Subject: UniStar Nuclear Energy, NRC Docket No. 52-016  
Response to Request for Additional Information for the  
Calvert Cliffs Nuclear Power Plant, Unit 3,  
RAI No. 281, Part 1: Introduction and Interfaces

**Response to NRC Request for Additional Information 281, Question 01-13,  
Calvert Cliffs Nuclear Power Plant, Unit 3,  
COLA Part 1, General Information**

**Calvert Cliffs Nuclear Power Plant, Unit 3,  
COLA Part 1, General Information  
Page Markups**

**Figure 1.0-1— Organizational Structure**

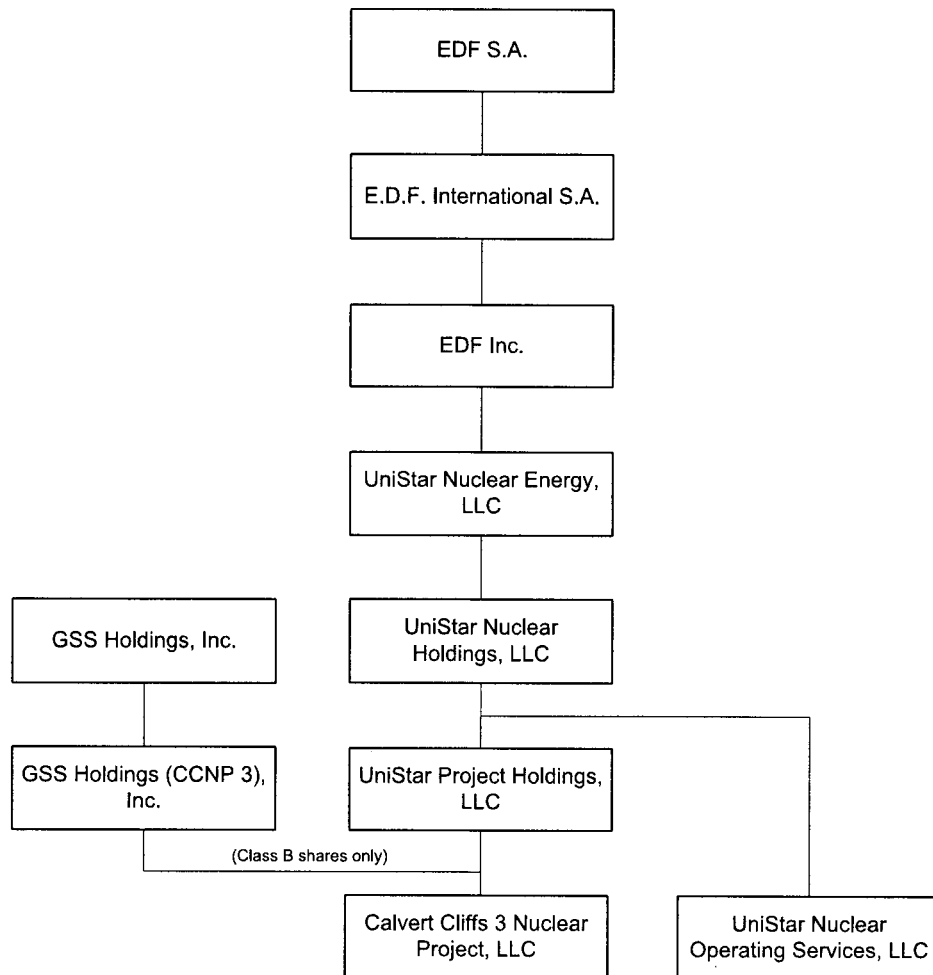
As shown on Figure 1.0-1, both applicant organizations share common parent organizations that lead to ownership by EDF.

**Figure 13.1-1— {UniStar Ownership and Technical Support}**

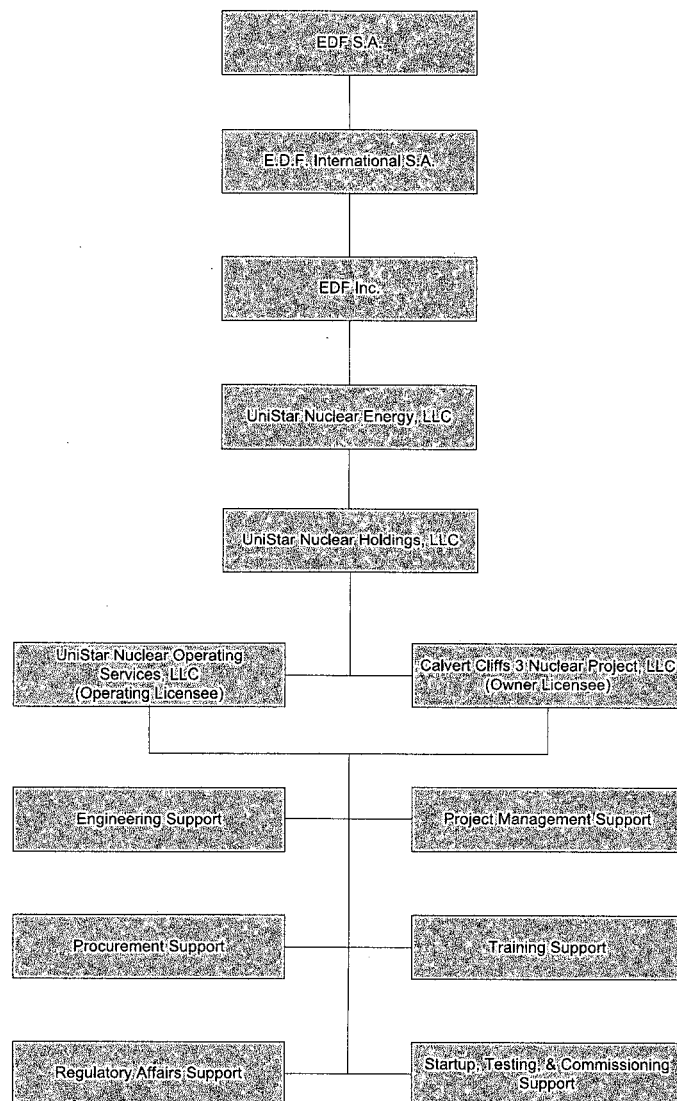
Calvert Cliffs 3 Nuclear Project, LLC and UniStar Nuclear Operating Services, LLC are owned by EDF Inc., which is an indirect subsidiary (through E.D.F. International S.A.) of Électricité de France, S. A. (EDF). Calvert Cliffs 3 Nuclear Project, LLC, as the owner and licensee, will develop and operate CCNPP Unit 3 through contractual relationships with UNE and its affiliates (see Figure 13.1-1).
